# Memo from the desk of the zoning administrator

Re: April 16 meeting notes

### Planning Commission Regular Meeting Agenda

# THE GROVE **MODEL MARKET OFFICE** SITE PLAN

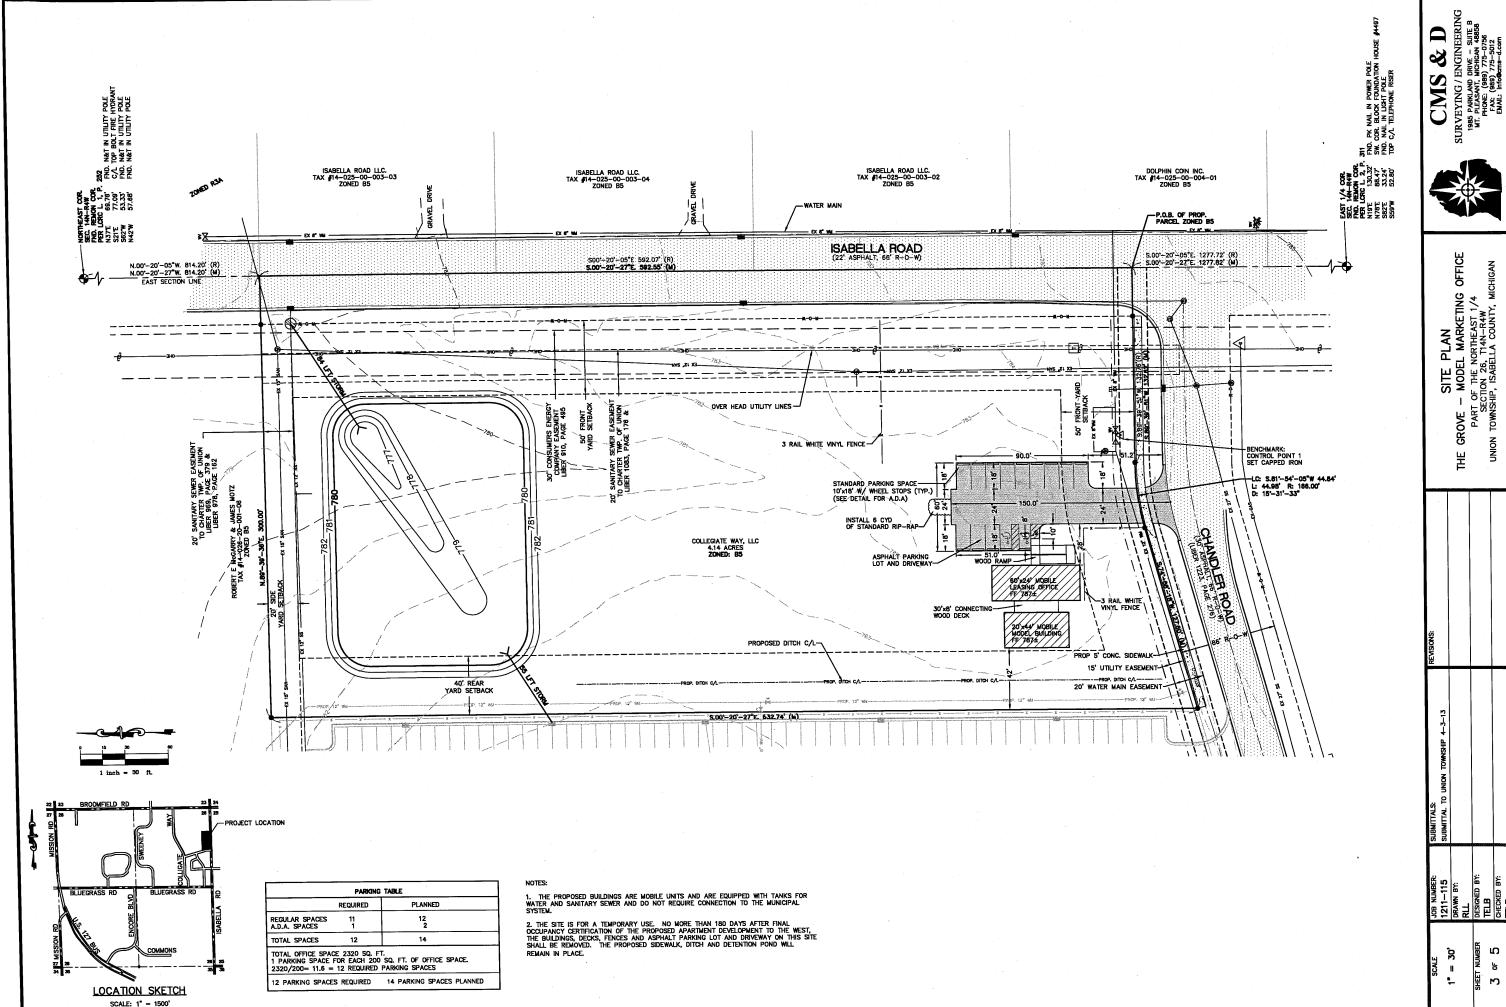
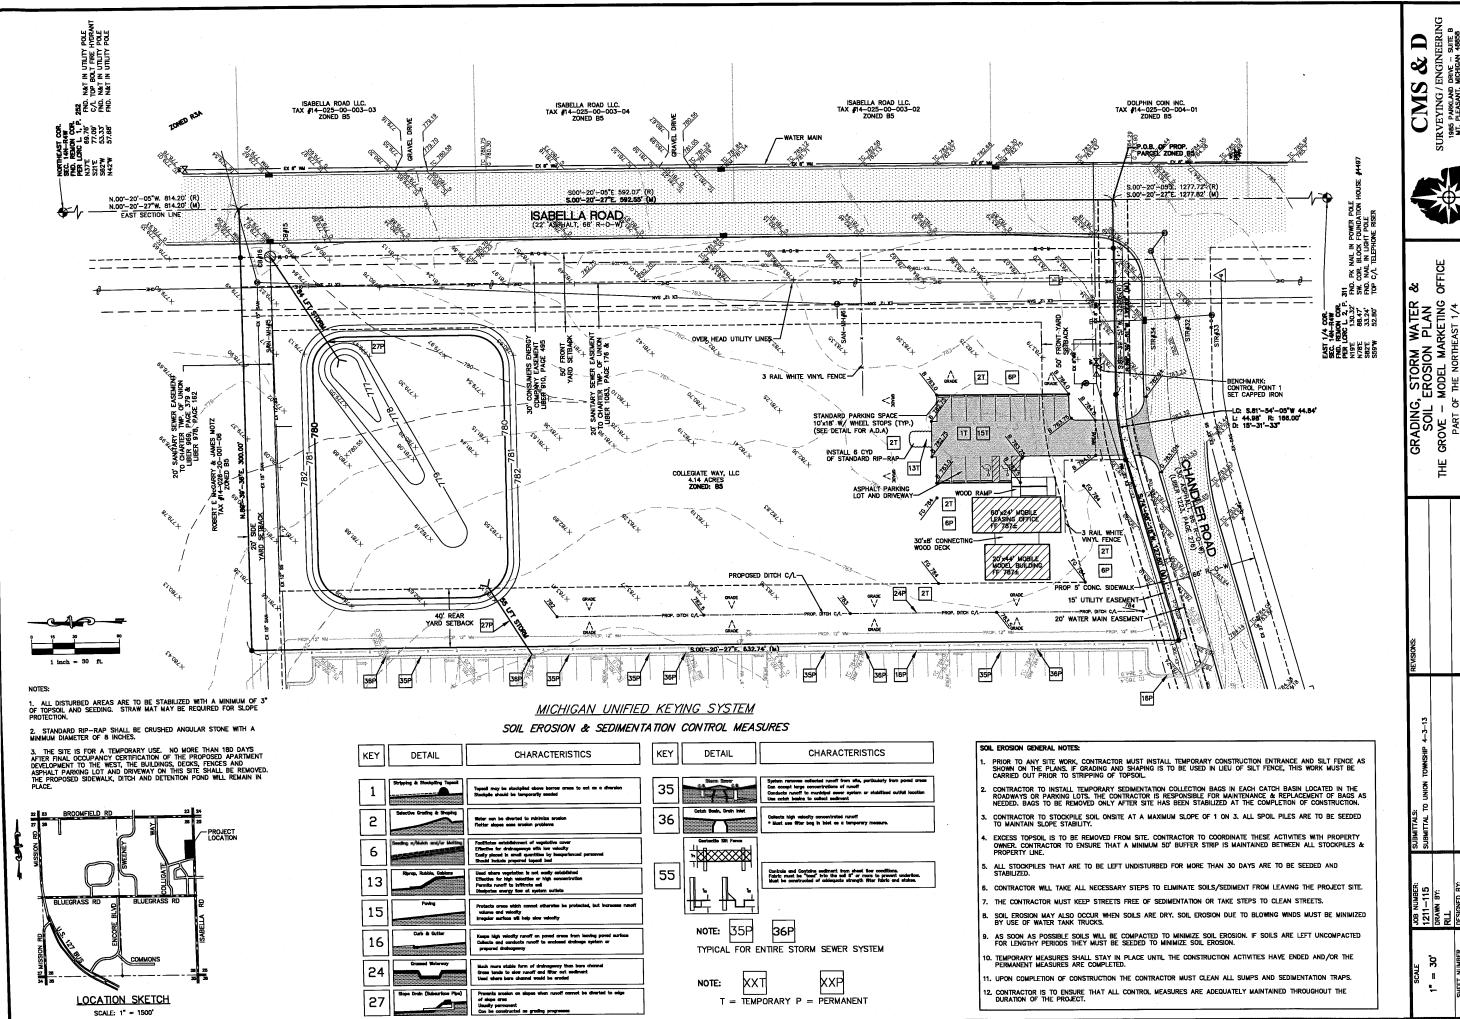
SPR 1670 – Leasing Office for Campus Crest Apartments. This use is on the Business portion of the Campus Crest Property. As a leasing office, it is a permitted use in B5 as an Office, see 23.2.A and 22.2.C. I note that these are "modular's". We have approved them in the past for offices, Burch Tank and the International RV office on Pickard. I would like you to have the applicant submit a landscape plan for my approval. I do not have the outside letters as of today, the transmittal cover letters from the applicant are included in the packet.

Sidewalks- They are provided on Chandler from the apartment section to Isabella Rd. They do not show them on Isabella frontage. I have spoken to the owner about granting easements over the easterly 12' of the entire property so that when we do the planned 8' sidewalks for the next phase of our sidewalk assessment district. If it is your desire is to require them at this time, they need to be 8' wide.

Township use	Comments per MPFD, Drain offic &
File # [470	Comments PRV MPFD, Drain Afic &  Anal Commission (eview) requirements  Itabella Rd Gillowalk Ecsement (121)
File #	Isabella Rd Gillowath Ecsement (121)
Receipt # 40740	
Date received 3/24/13	
Date review completed by Zoning Adn	ninistrator
Place on the Planning Com	nmission Agenda
Planning Commission Decision

## THE GROVE SITE PLAN

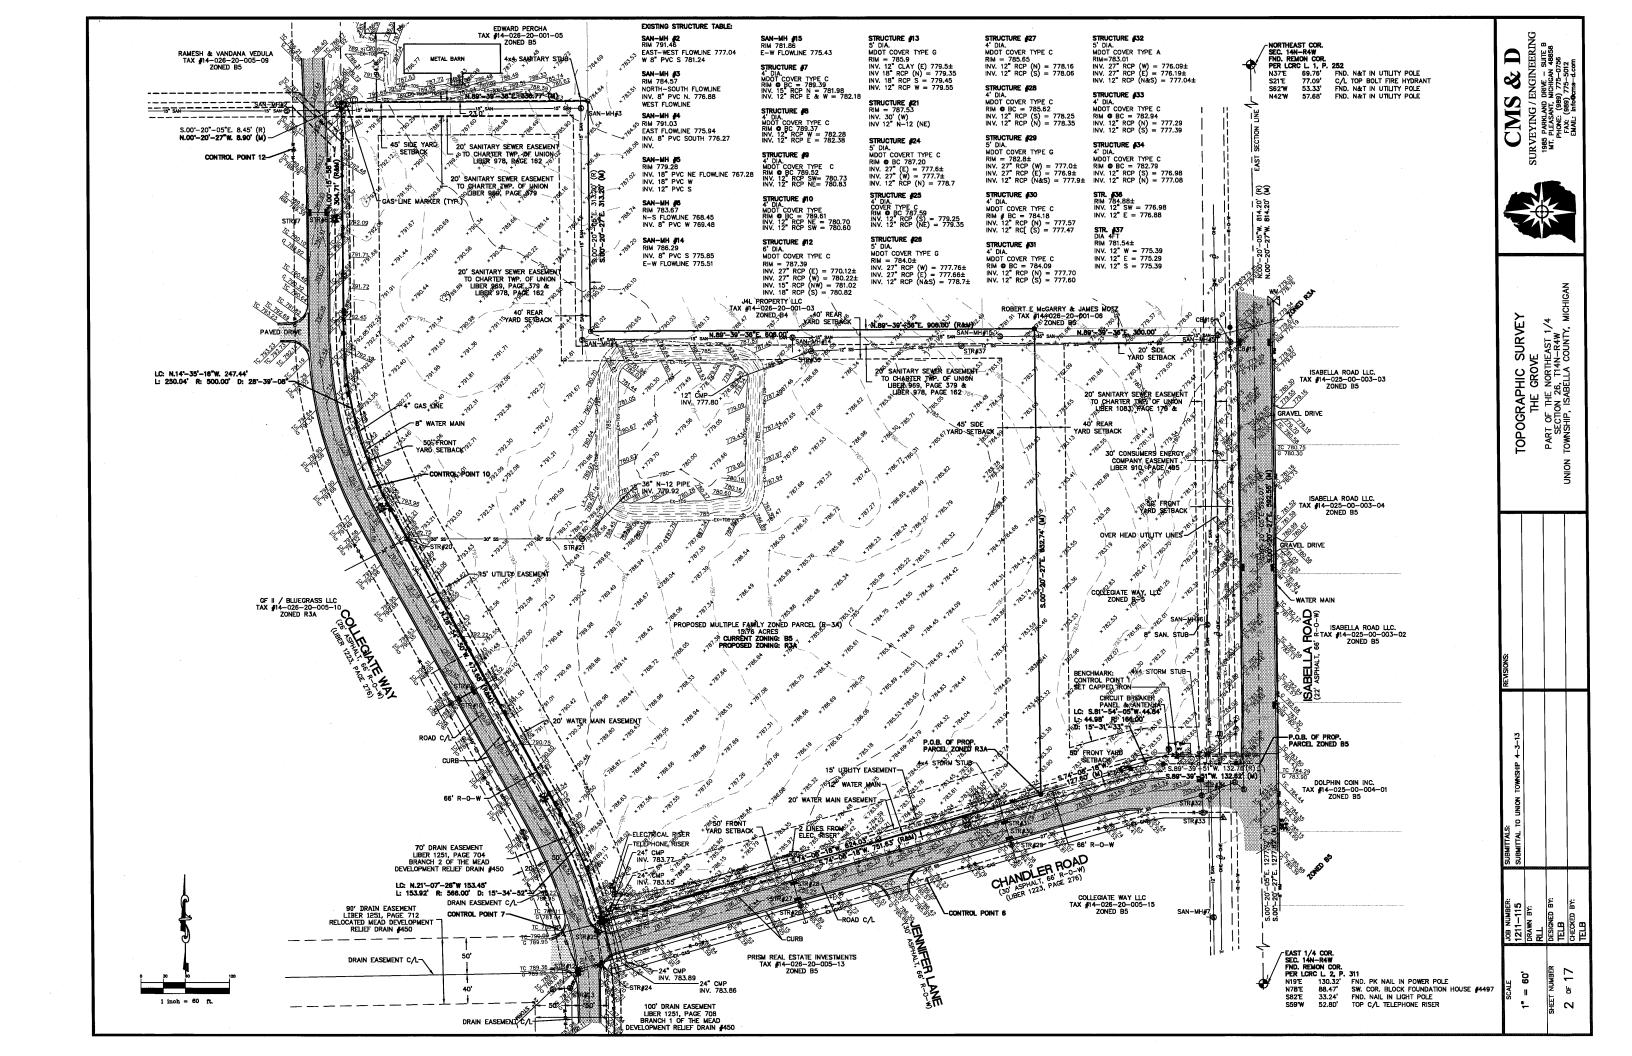
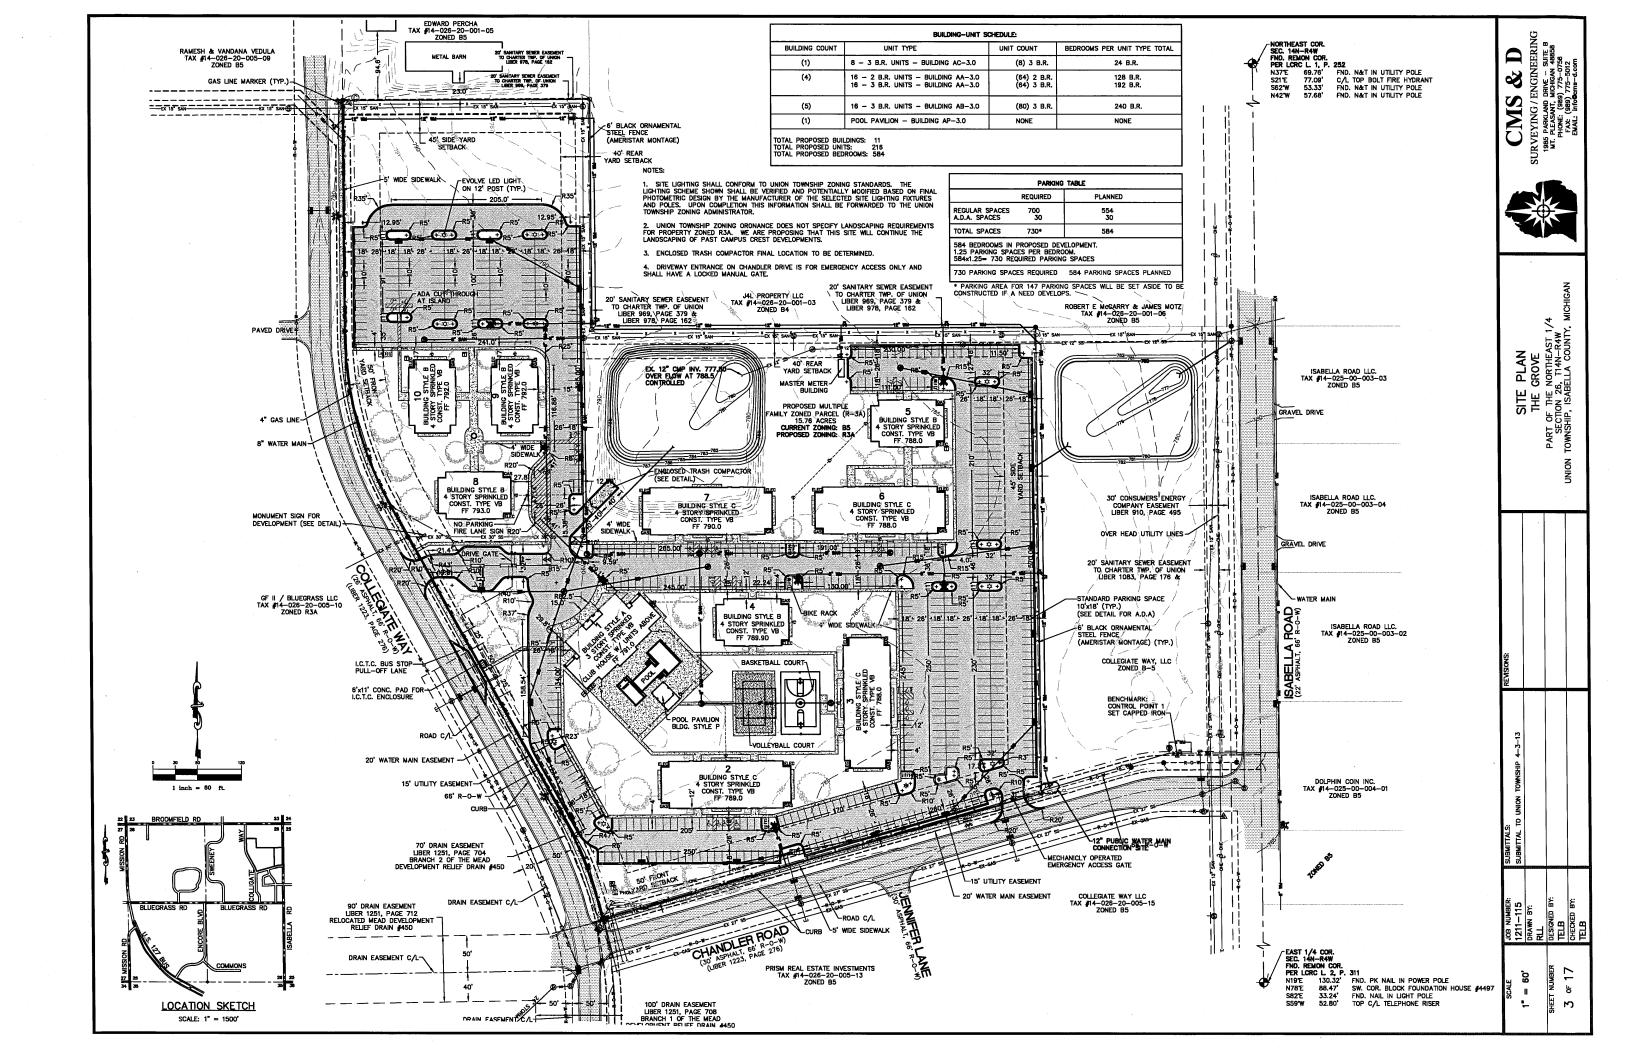
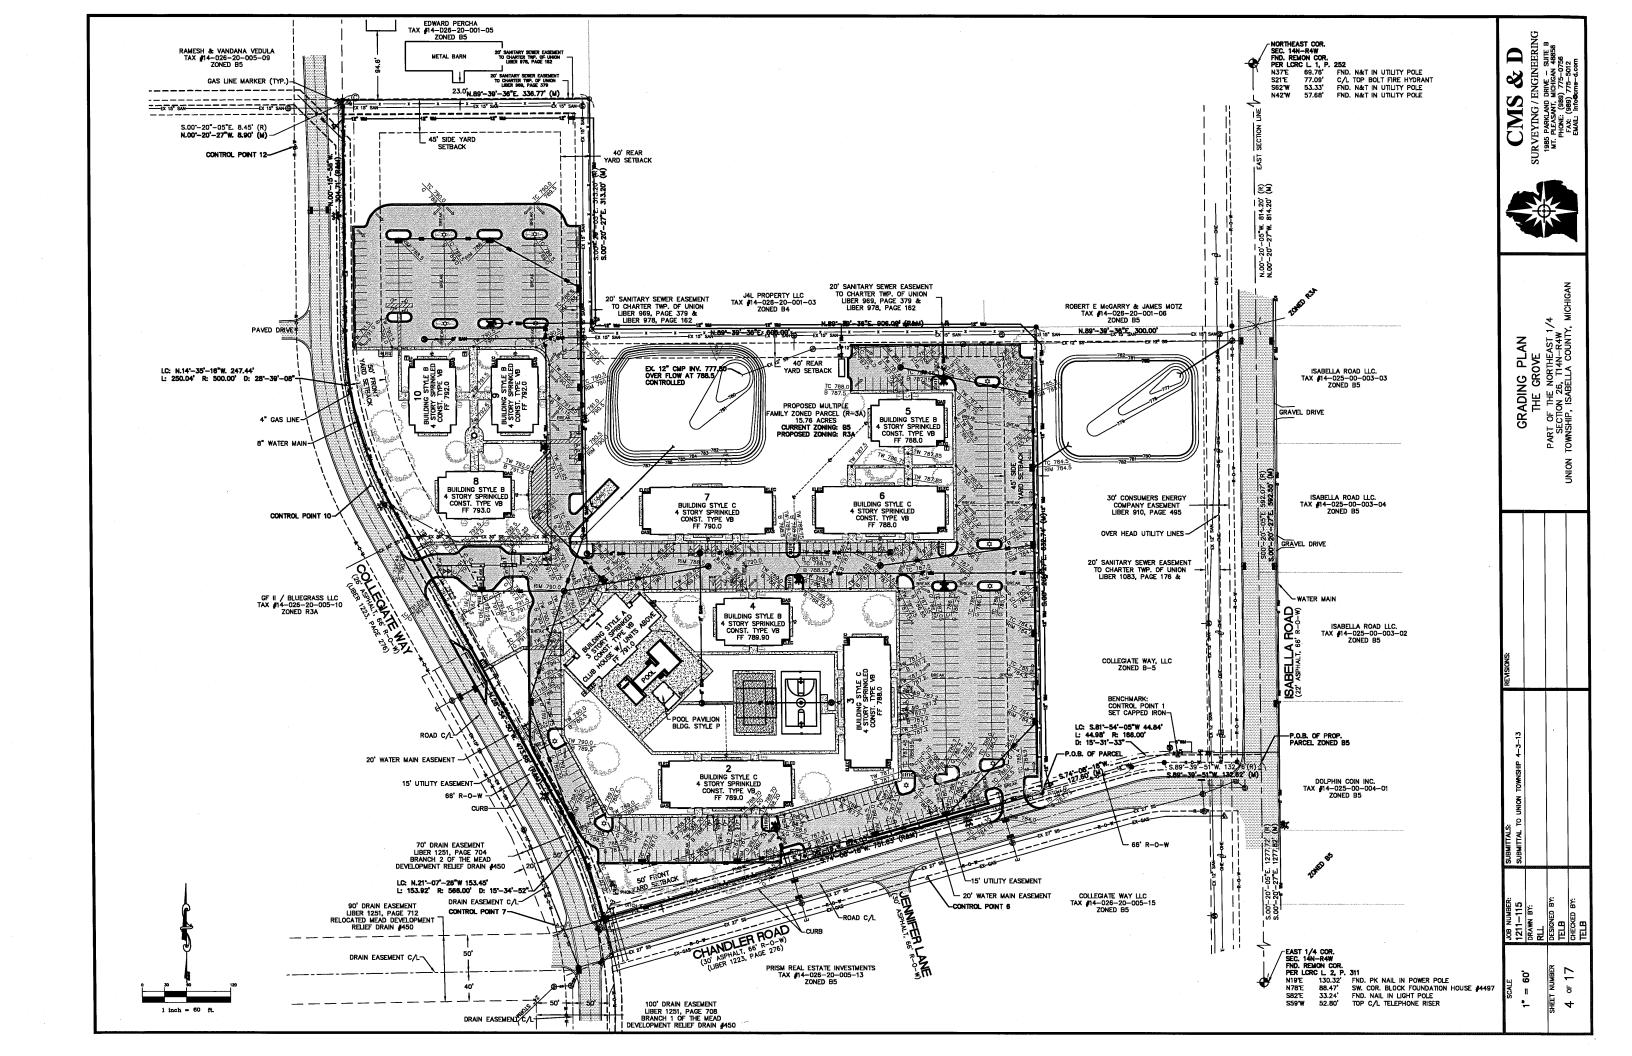
SPR 1676 - Campus Crest Apartments. We have looked at this plan before, and it has changed very little. It has been designed to meet our requirements. I recommend approval contingent on MPFD, ICRC and Drain Office requirements.

Township use	Comments approve per MPFD,
File # 1676	ICRC & Drain Office Repairement
Fee Paid initial MM	,
Receipt # 70739	
Date received 3/24/13	
Date review completed by Zoning Adn	ninistrator
Place on the 4/14/13 Planning Com	nmission Agenda
Planning Commission Decision
